A FLECK PERFORMANCE BULLETIN

September 27, 1991

3900 Soft Water Regeneration

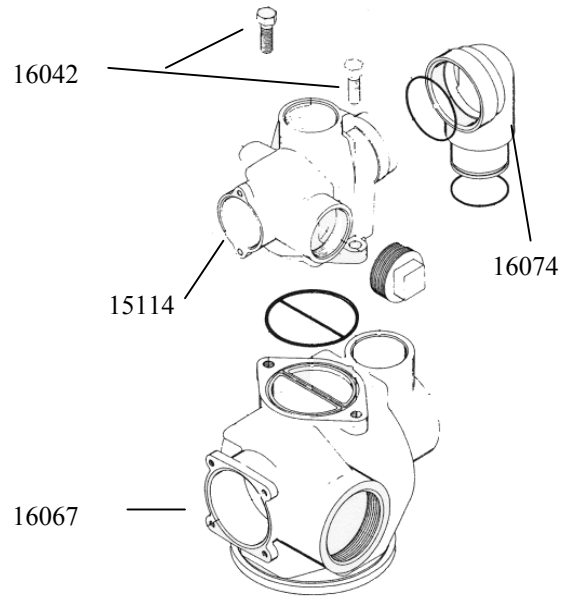
The 3900 control is now available with soft water regeneration. It is recommended that when using the soft water regeneration option, it is ordered with the control. In the event of having to modify a unit, it will be necessary to drill two holes in the lower casting. If you have a 3900 control, which needs the soft water regeneration modification, the next page will show how to modify.

3900 Conversion for Soft Water Regeneration

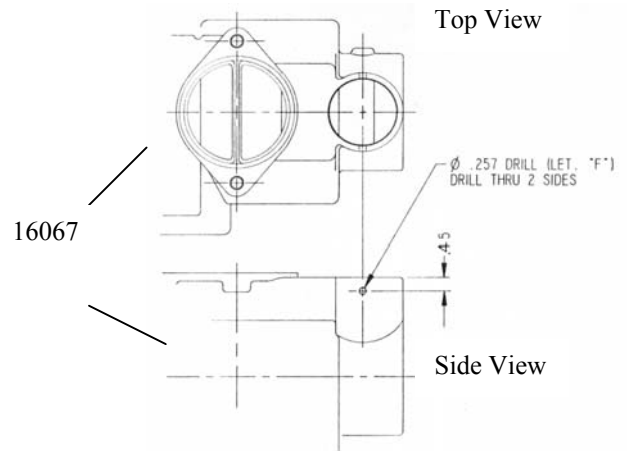
1. Remove upper and lower powerheads.
2. Remove 2-screws (16042), remove the upper valve body (15114) from the lower valve body (16067).
3. Remove coupling (16074).

4. Drill size 0.257 (Letter "F")
5. .45" from top of valve body
6. Before drilling hole, install 17453 sleeve, grease 16077 o-ring, then slide in 17454 plug. This will stop shavings from entering the valve body.

7. Drill holes thru 2 sides of the lower valve body (16067).
8. Insert 17452 shaft thru the drilled holes.
9. Snap 10250 clip to each side of the 17452 shaft.
10. Reinstall upper valve body 15114 and upper/ lower power heads.
11. Raw water to inlet lower valve body (16067).
12. Treated water to inlet upper valve body (15114).
